**INFORMAL GROUP ON GASEOUS FUEL VEHICLES
Within the UN GRPE (WP29)**

CLEPA : European Association of Automotive Suppliers

Regulation 83

Amendment to Regulation R83 and document ECE/TRANS/WP29/GRPE/201 regarding the use of petrol in gas mode and its limitation for bi-fuel gas vehicles and the verification during type approval.

Figure 1: Comparison of fuel consumption measurement in the NEDC.

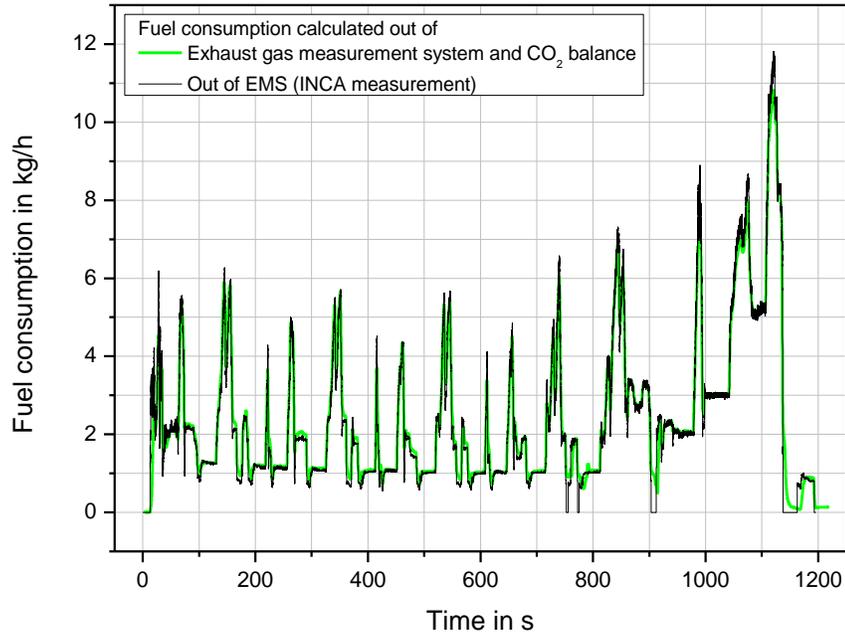
As an example, figure 1 is showing a comparison of fuel consumption measurement (modal data) in the NEDC for a vehicle equipped with a mono-fuel CNG engine.

- Firstly the FC was determined by the exhaust gas measurement system using the CO₂ measurement data (carbon balance method) in the test center.
- Secondly the FC was calculated from the injected fuel mass in the engine control unit.

It can be seen, that the results from both measurement systems show the same behavior.

Figure 2: Integrated values of fuel consumption measurement in the NEDC.

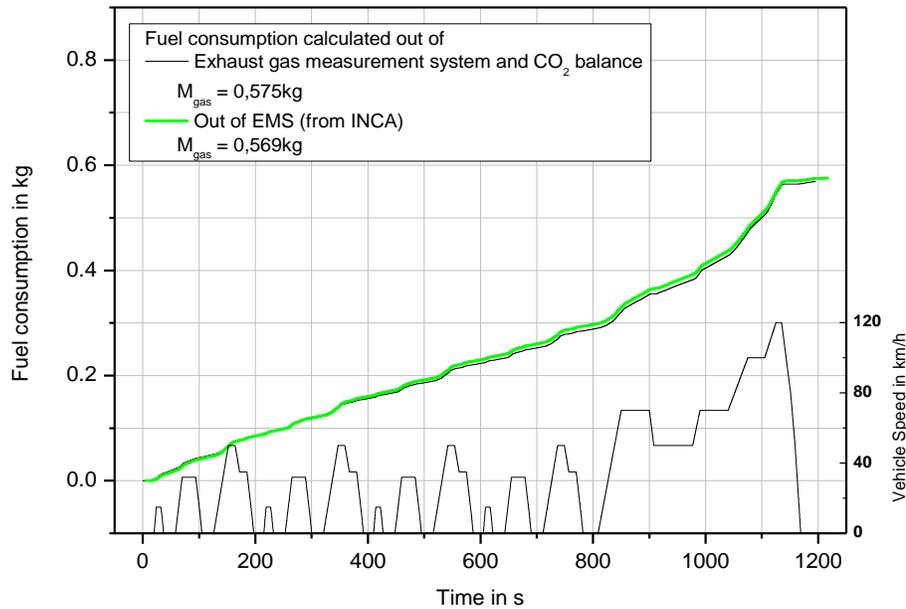
In figure 2, the modal FC values in kg/h were integrated to a total FC in kg over the whole cycle. Here it can be seen, that the deviation is below 2% of the overall injected fuel mass.

Figure 3: Calculated CO₂ dependent on petrol fuel amount

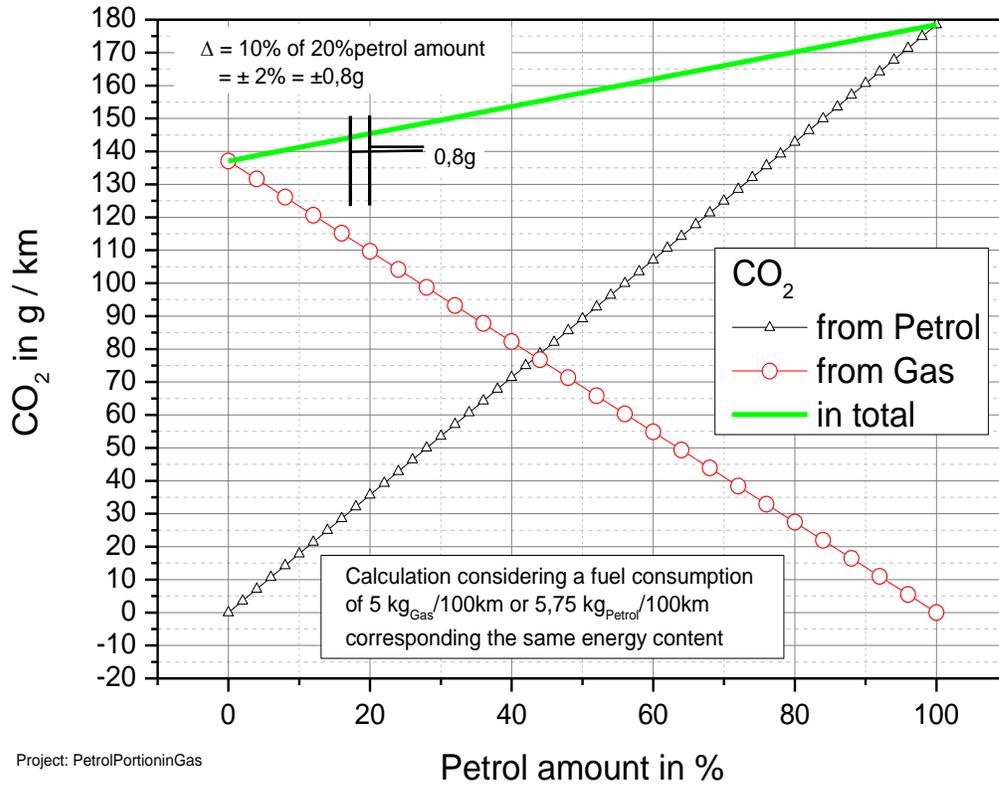
From figure 3 it can be seen, that the M_{Petrol} increase will lead to an increase of the CO₂. Assuming a NG consumption of 5kg/100km and the same energy consumption in NG and petrol operation, the CO₂ emission increases by 0,4144g for each % replacement of NG by petrol. With the above described CO₂ calculation the values out of the control

unit can be verified by entering the data in the CO₂Total equation and comparing it with the bag values from the emission test. A deviation of +/- 10% on the petrol / gas share will lead to an error of +/- 2% in the CO₂.
